Turbo HD DVR V4.20.000build 181107 Release Notes (2018-11-15)

Firmware Basic Information	Firmware Version:	V4.20.000 build 181107
	SDK Version::	V5.3.6.35_build20180830
	Onvif :	V2.2
	Player :	4.8mini
	Player library :	7.3.3.64 build171113
	Web version :	V4.0.1build180929
	Client version :	V2.6.11.4 build20180831

2) Preview menu

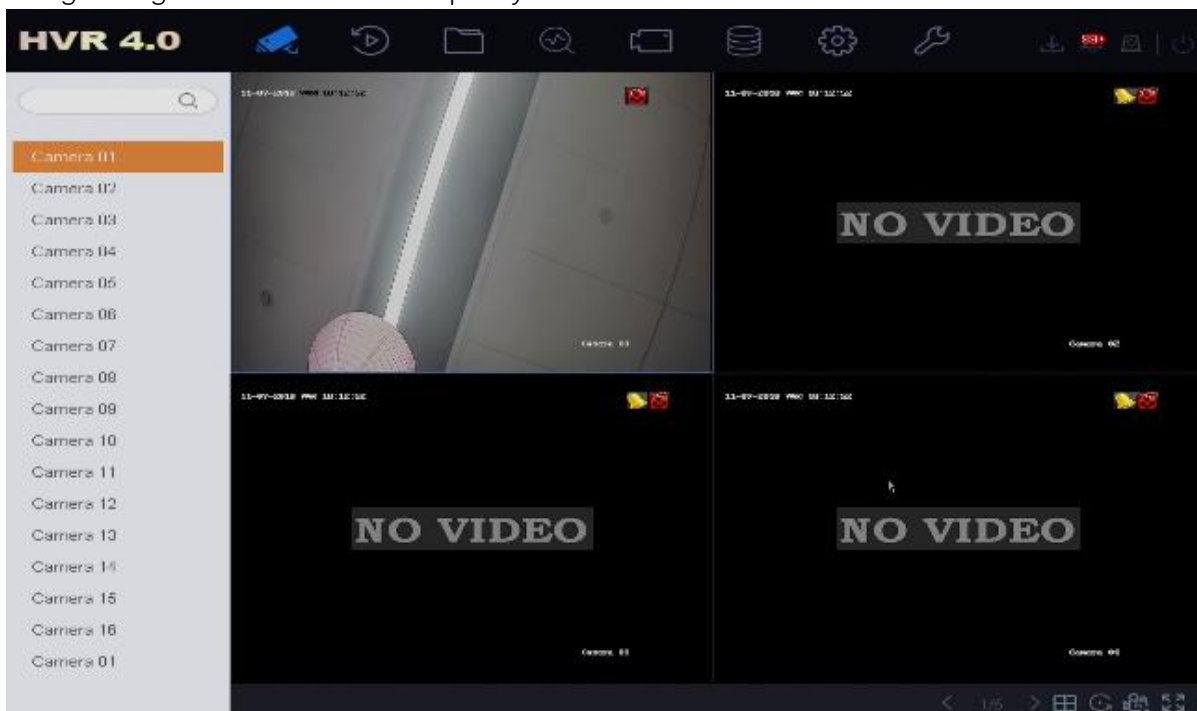
Using the right mouse button can quickly enter and exit the full screen.

6) Admin user can set local live view permission for guest and operator user.

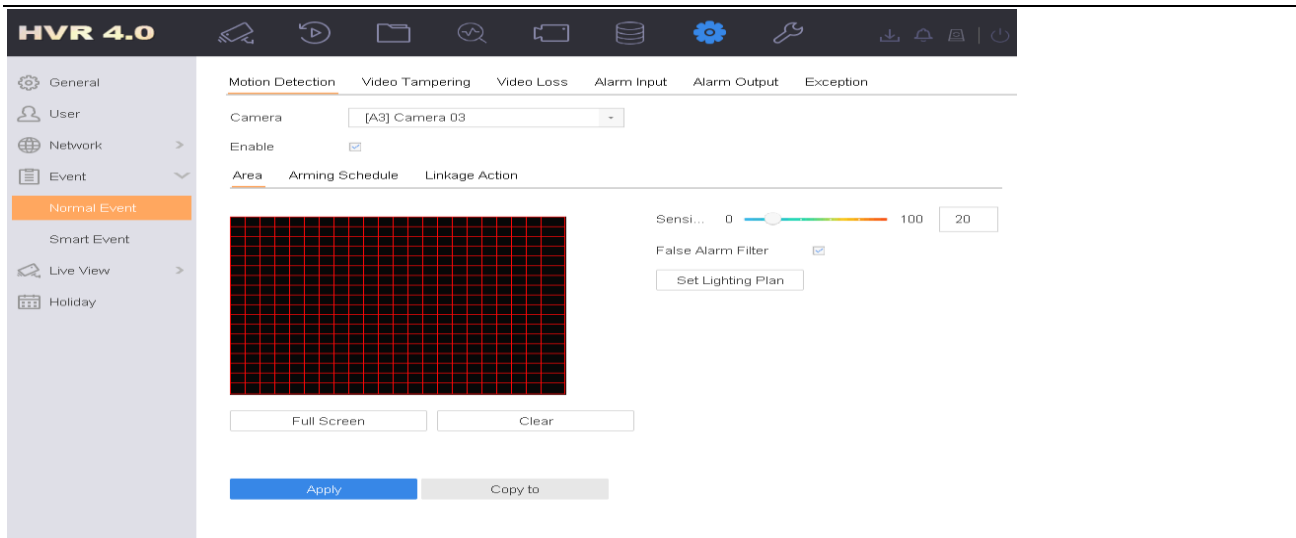
Configurations of local GUI as below:

System-User-Check the guest user -Camera Configuration-Camera permission-Local Live View
